U.S. Custom House Old Jail

Town of Barnstable ADA Transition Plan

August 2021

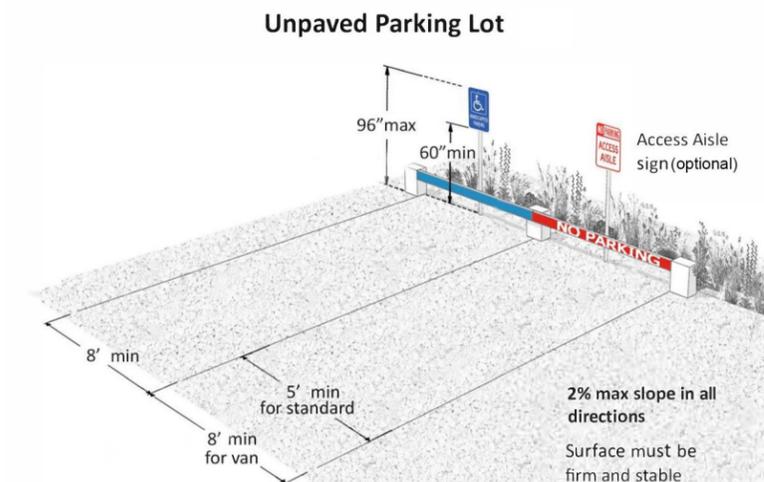
Note: This image shows one solution for designating an accessible parking space in unpaved parking lots.
